Technical Service Information

DODGE 68RFE

VALVE BODY AND SOLENOID ASSEMBLY CHANGES FOR LATE 2010 AND UP

Figure 1

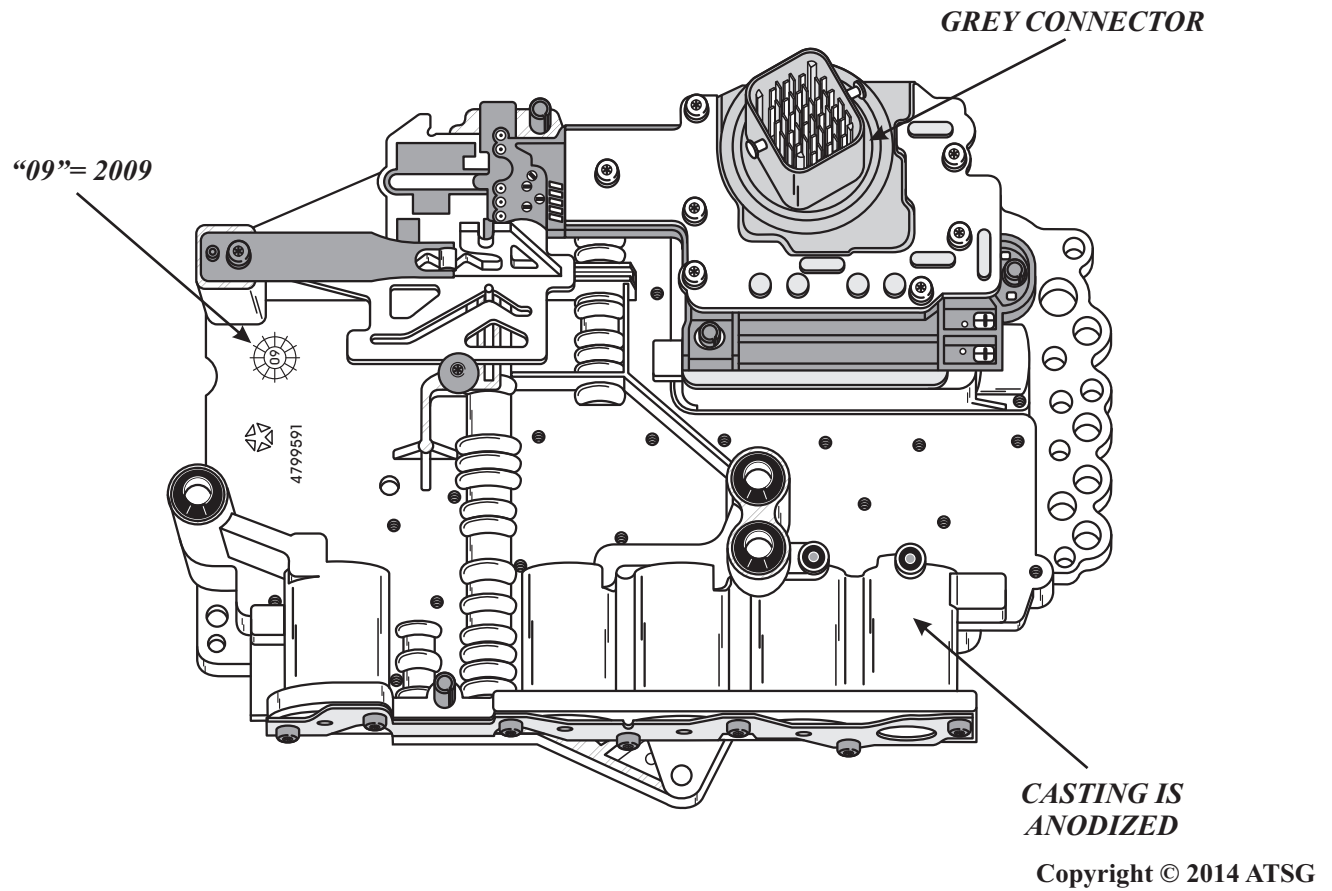
CHANGE: Sometime late in the 2010 model year, the 68RFE transmission acquired a new valve body and Solenoid assembly that has eliminated the Overdrive Solenoid. See Figure 1 for quick identification by casting date.

Figure 2

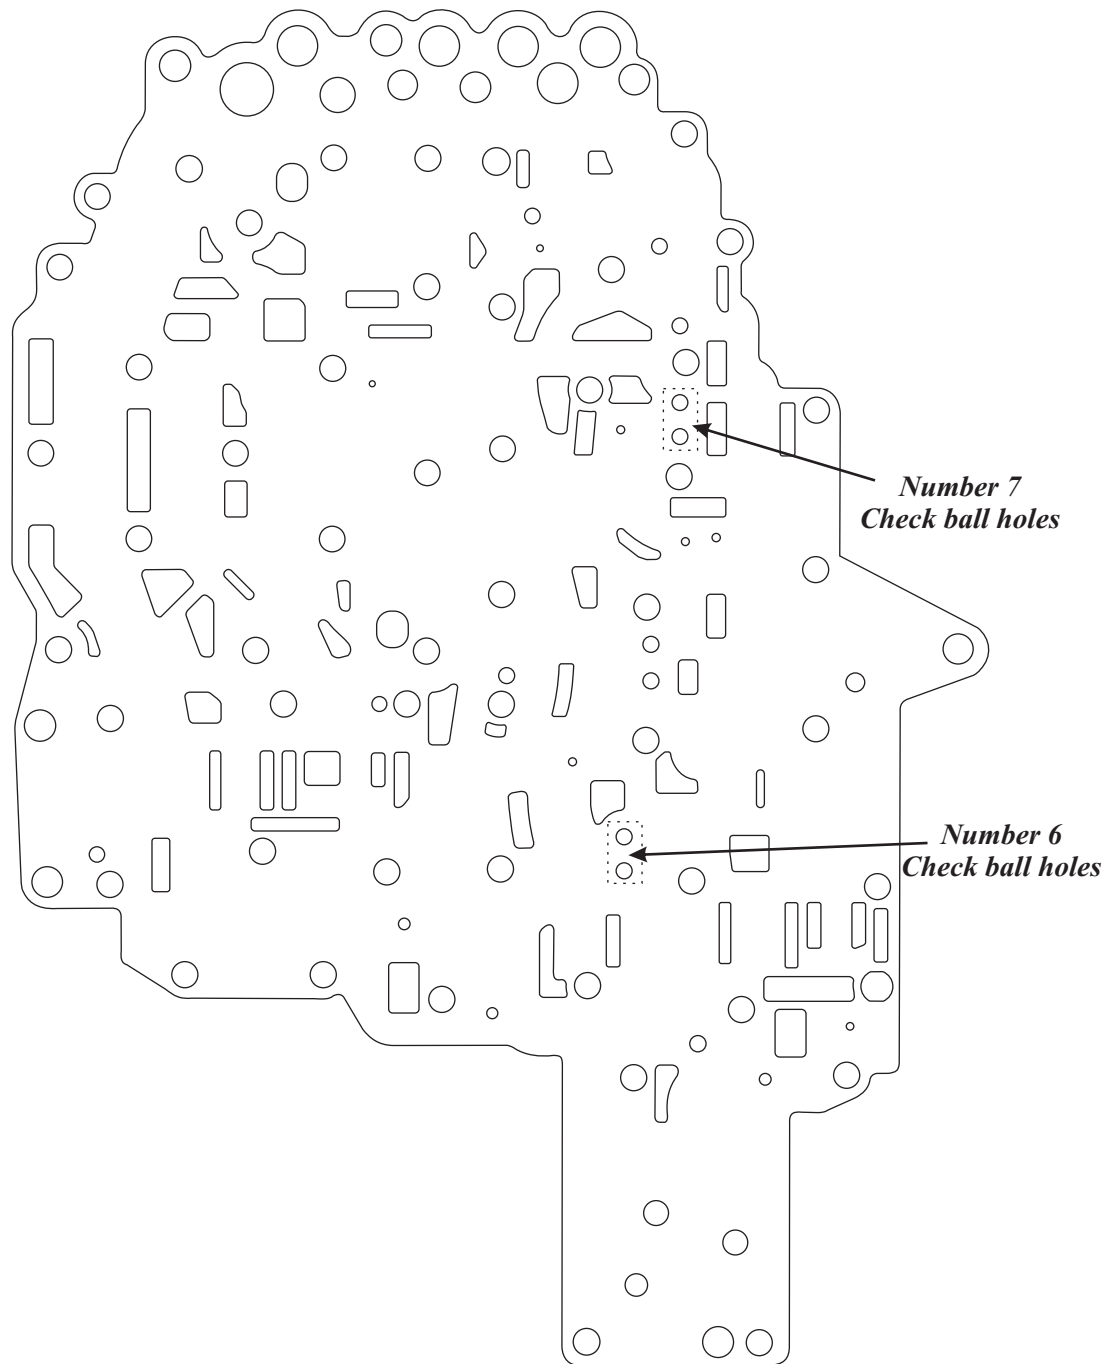
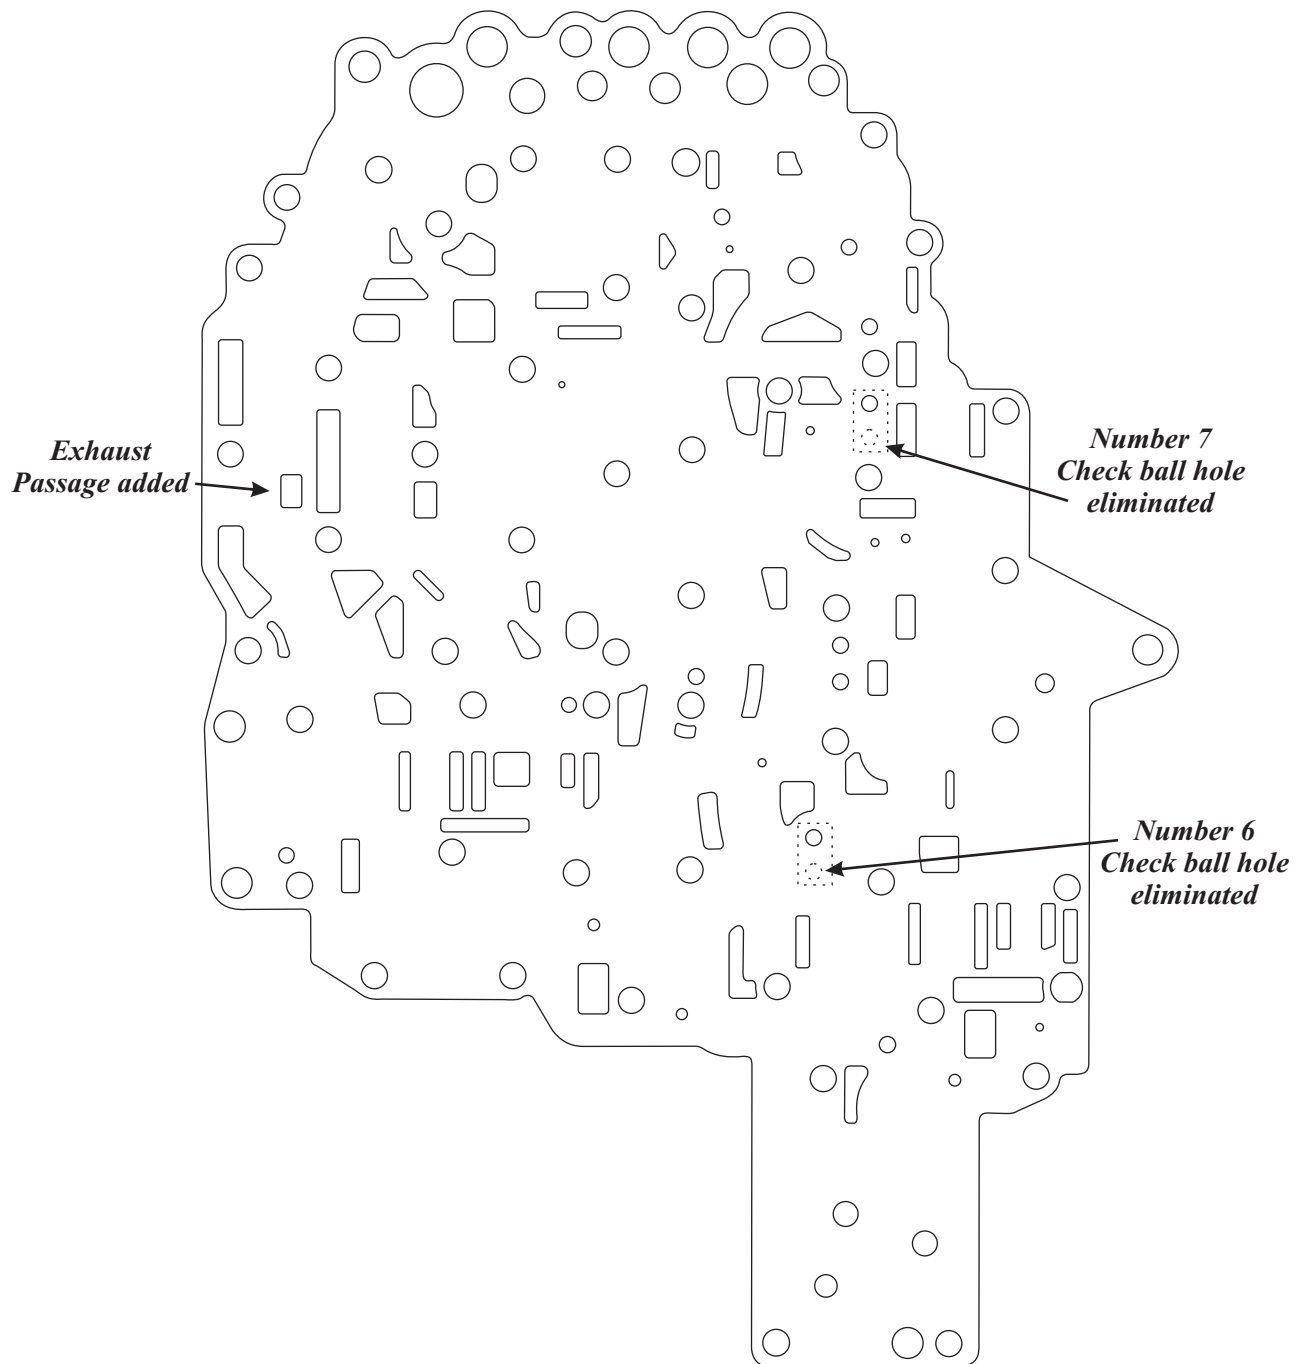
- **SPACER PLATE-** The Spacer plate changed in the area of the Number 6 and number 7 Check ball, as these check balls have been eliminated. **Note:** one hole over the bathtub area of the valve body has been eliminated and an exhaust passage was added. See Figures 2 and 3 for spacer plate comparison from previous design to new design.

Figure 4

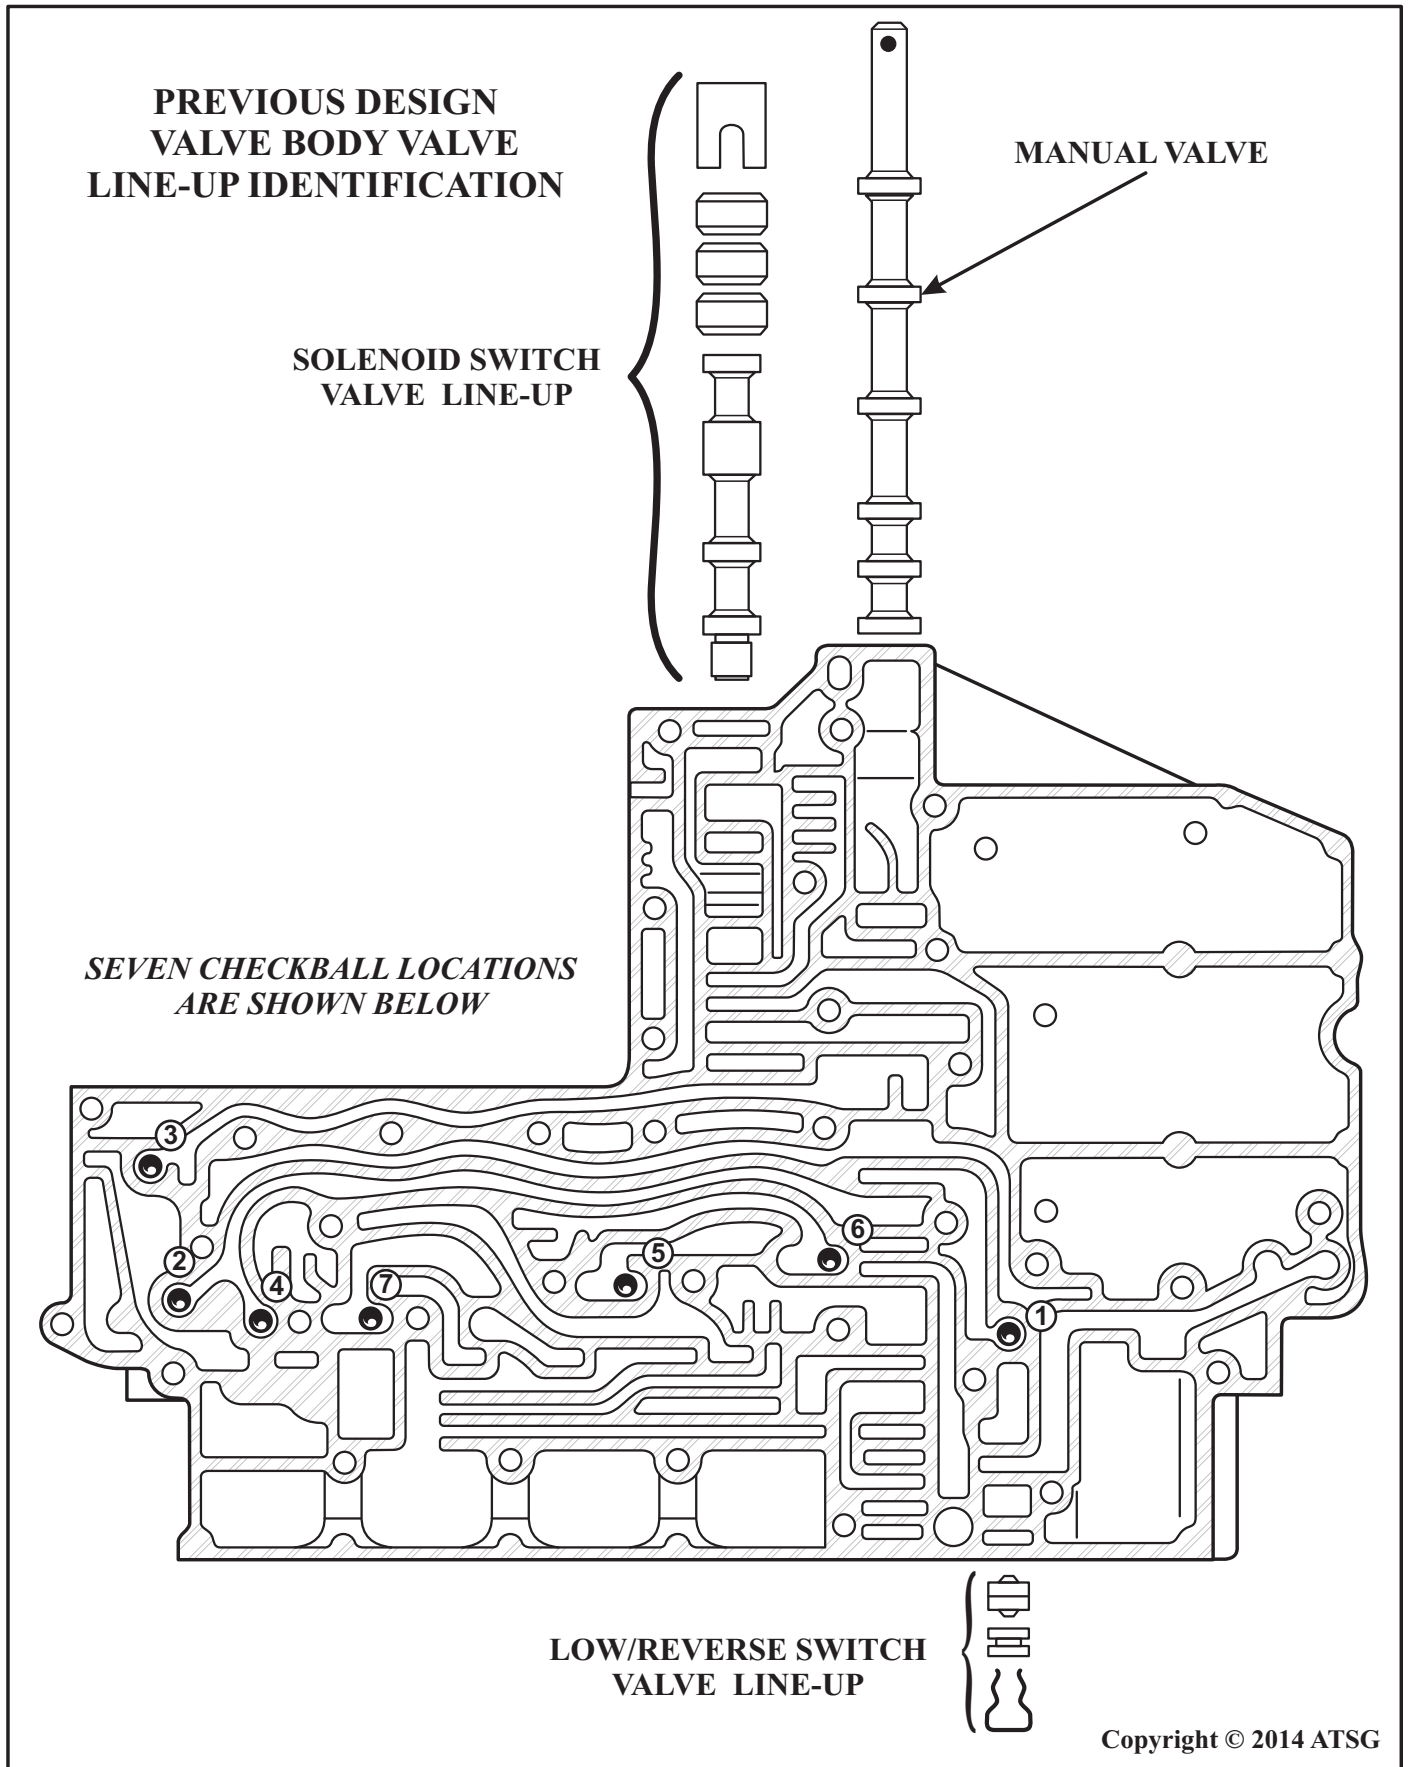
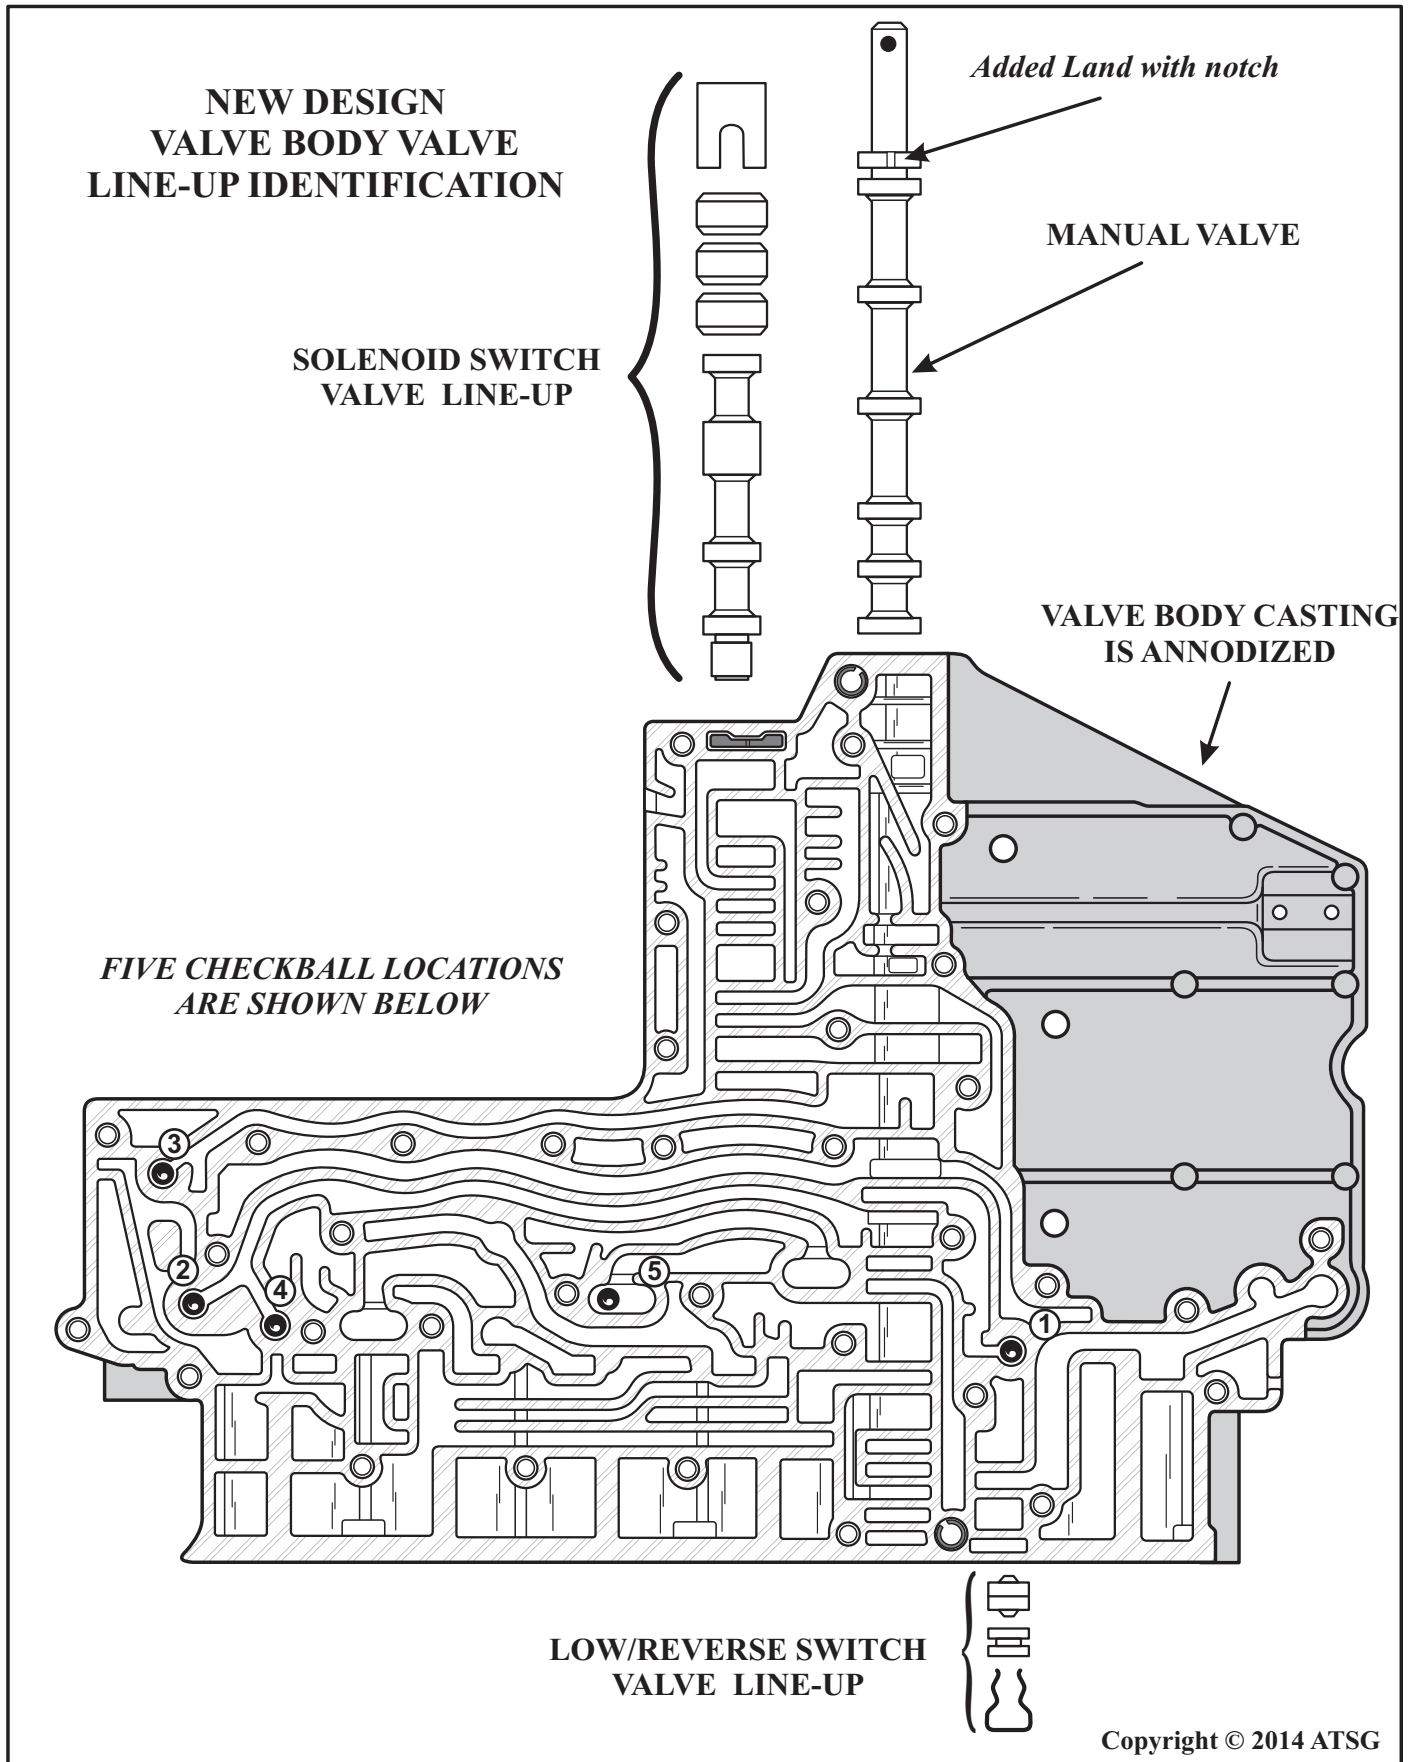
- **MAIN VALVE BODY-** The Main Valve body was anodized to help prevent Solenoid Switch Valve wear out. An exhaust passage was added in the top of the casting and the Manual Valve had a new land added to it with a small notch. Number 6 and 7 Check balls were eliminated. Refer to Figures 4 and 5 for a comparison of these changes from previous to new design. See Figures 6 and 7 for a comparison of the previous design oil circuit diagram using check ball 6 and 7 and compare it to the new design oil circuit diagram with the number 6 and 7 check balls eliminated and the Overdrive Solenoid eliminated.
